ADDENDUM NO. 1

City of Spring Valley, MN
Wastewater Treatment Facility Improvements
Bid Date: October 27, 2026
Bid Time: 2:00 PM
BMI Project No. 0M2.131536

SHEET
7.12

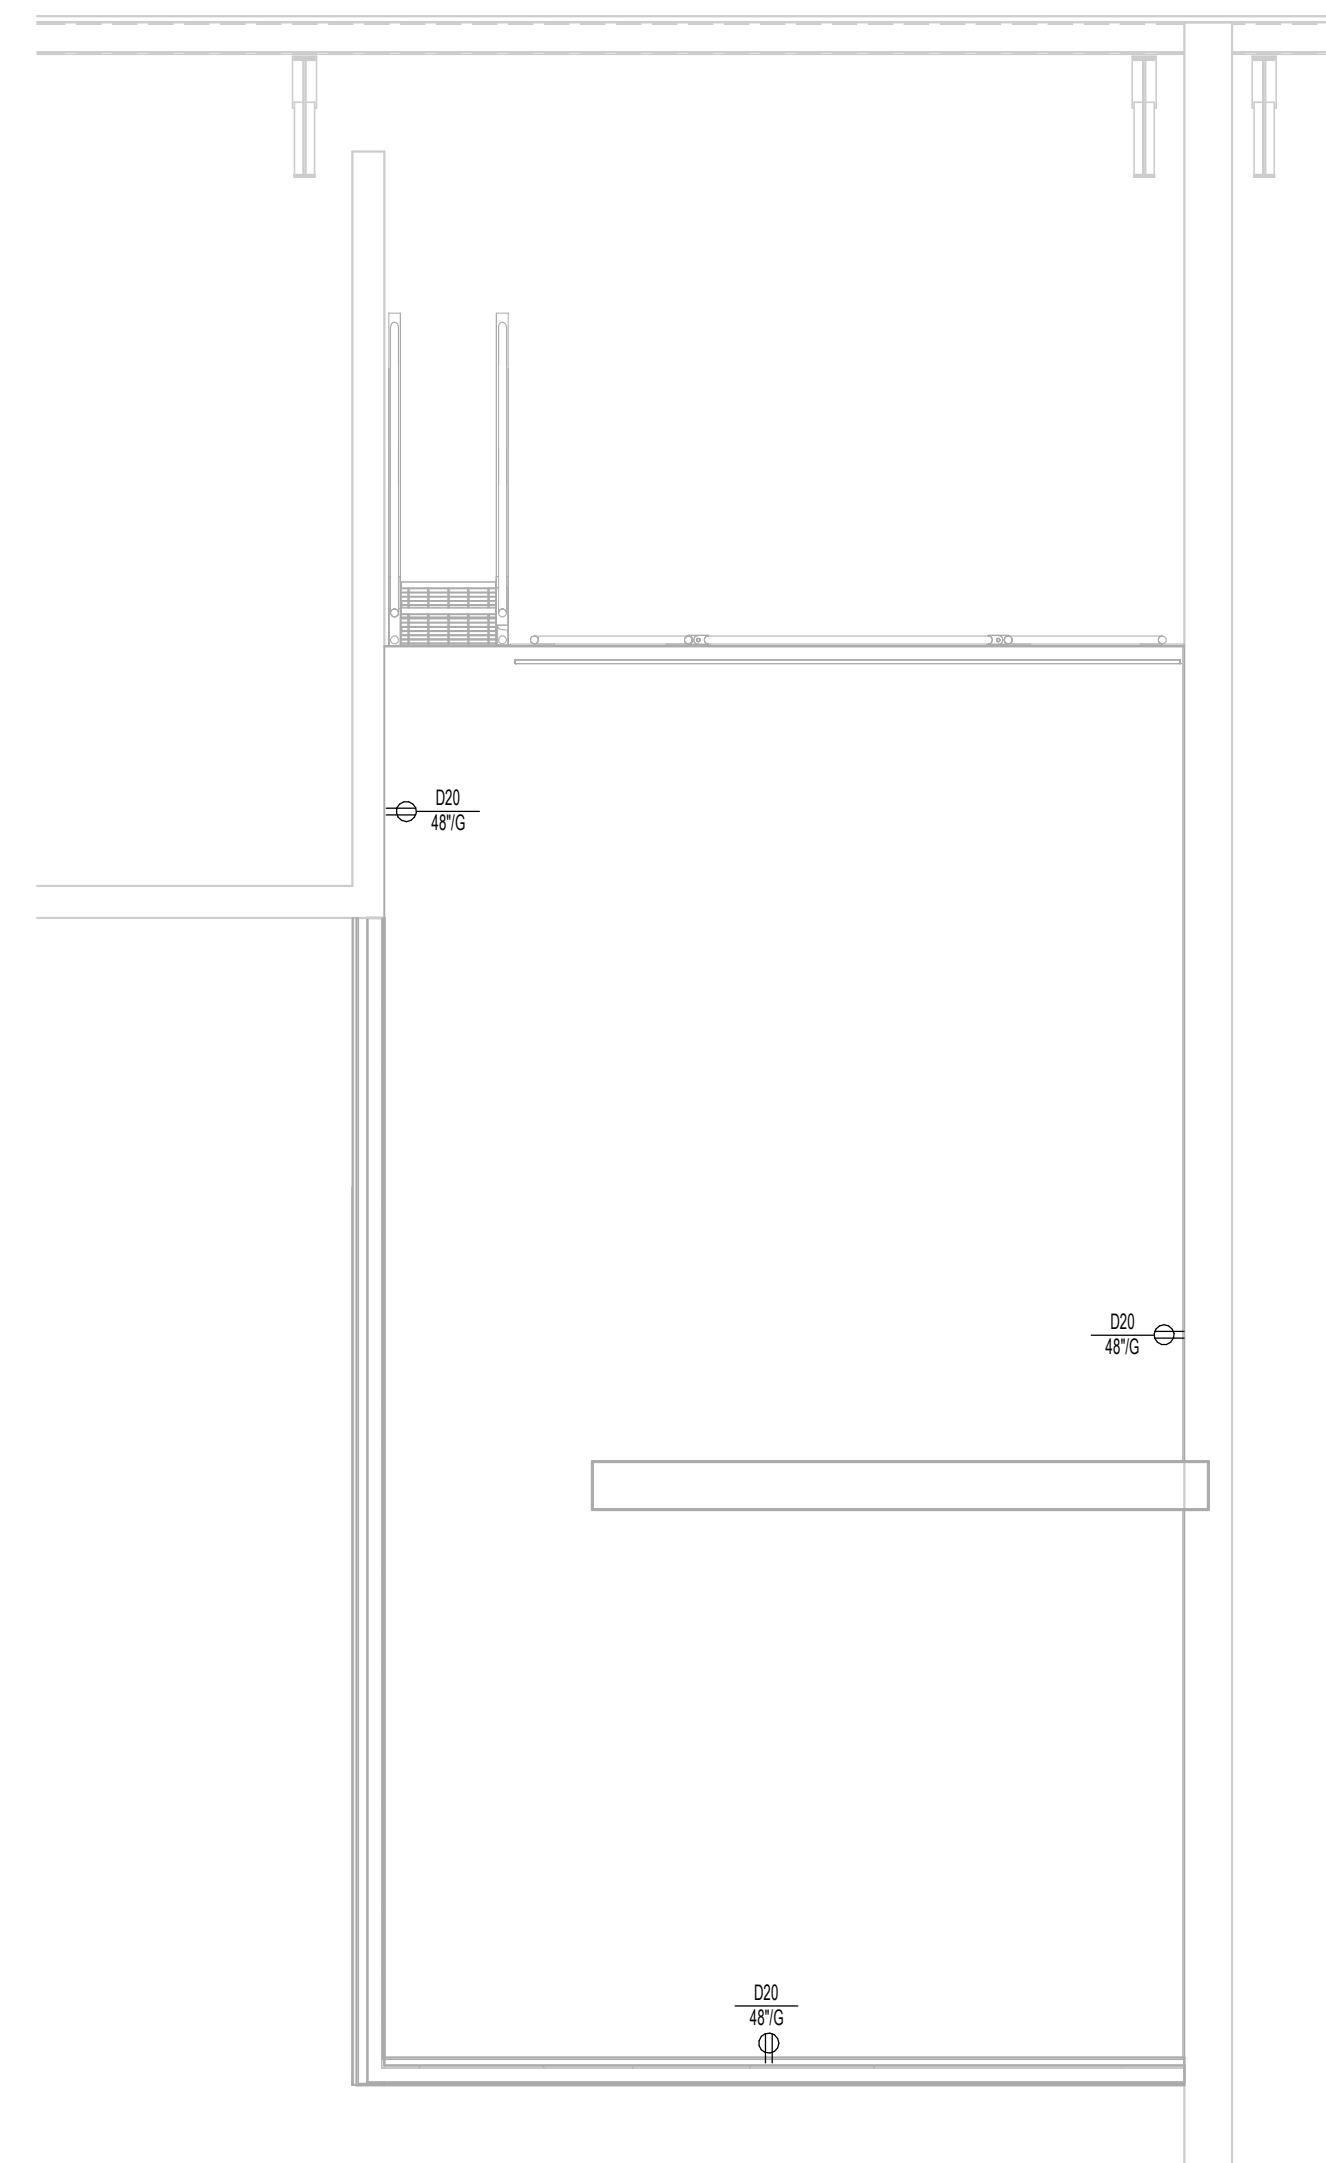
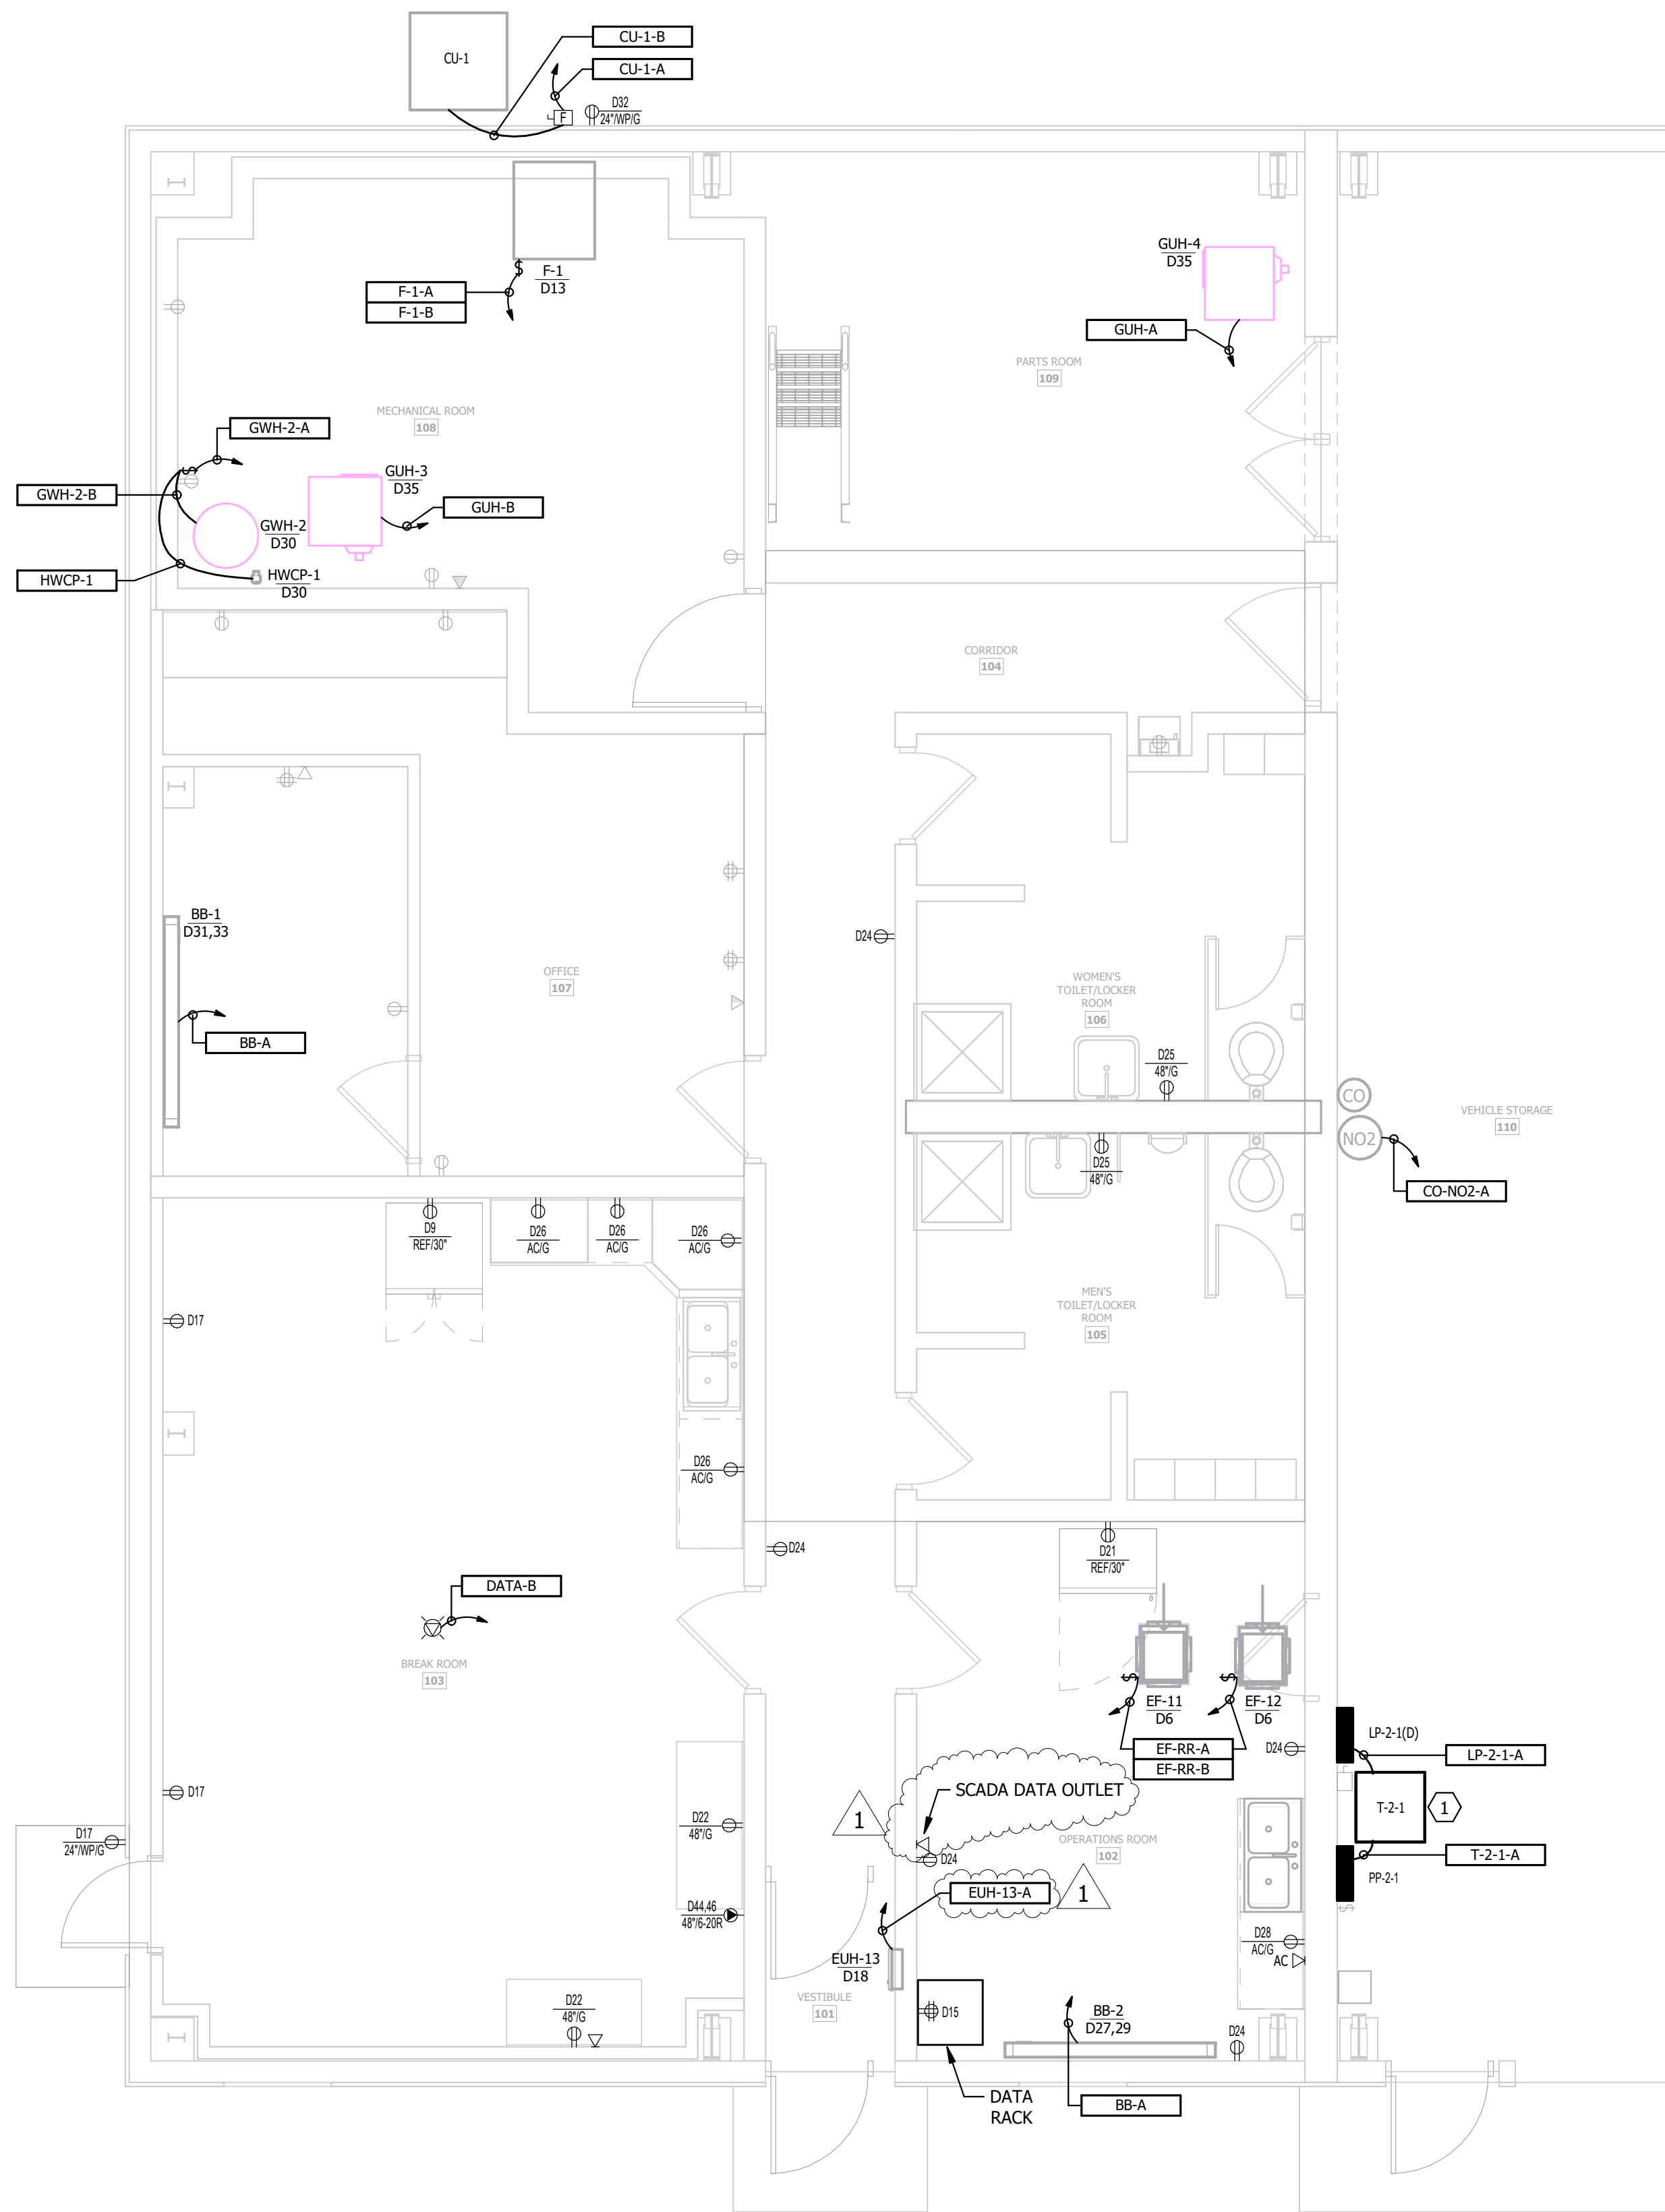
- a. Replace Sheet 7.12 Rev 0 09/29/2026 with attached Sheet 7.12 Rev 1 10/08/2026.
- b. Remove wire tag 'DATA-A'.
- c. Call data outlet out as SCADA Outlet.

SHEET
7.13

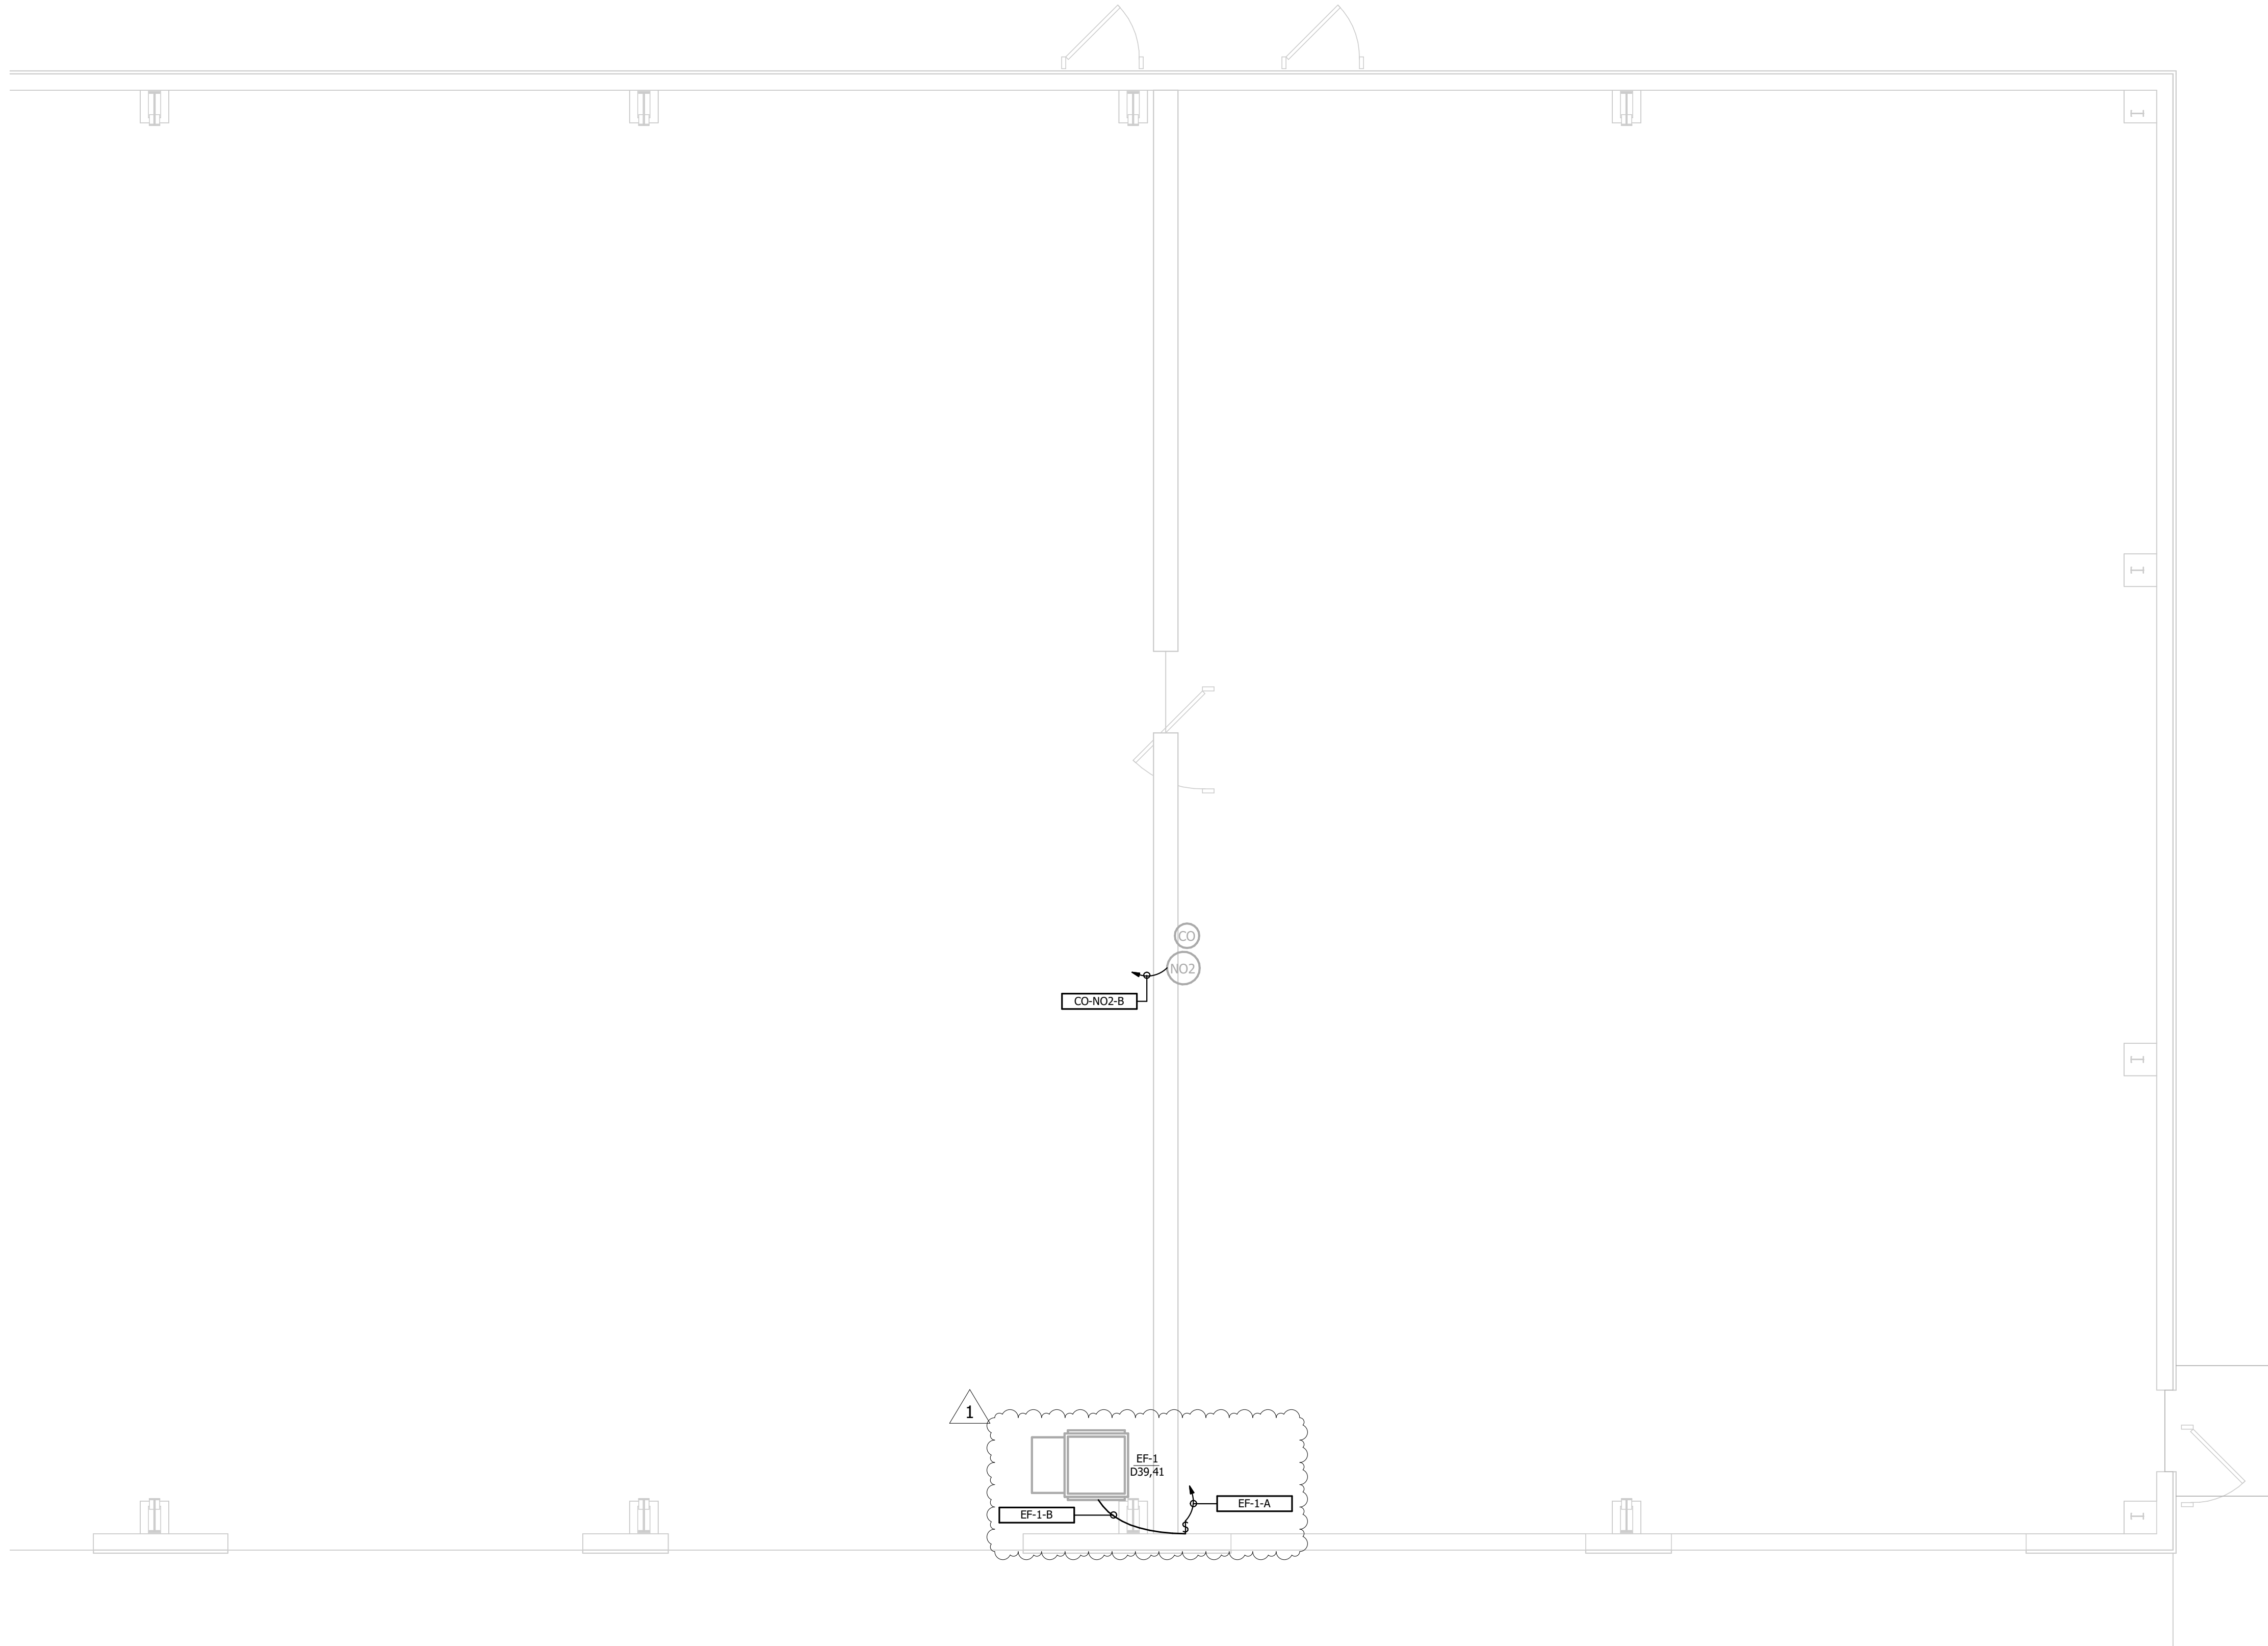
- a. Replace Sheet 7.13 Rev 0 09/29/2026 with attached Sheet 7.13 Rev 1 10/08/2026.
- b. Add wire tag 'EF-1-B'.
- c. Revise wire tag 'EF-1-A'.
- d. Relocate disconnect to garage wall.
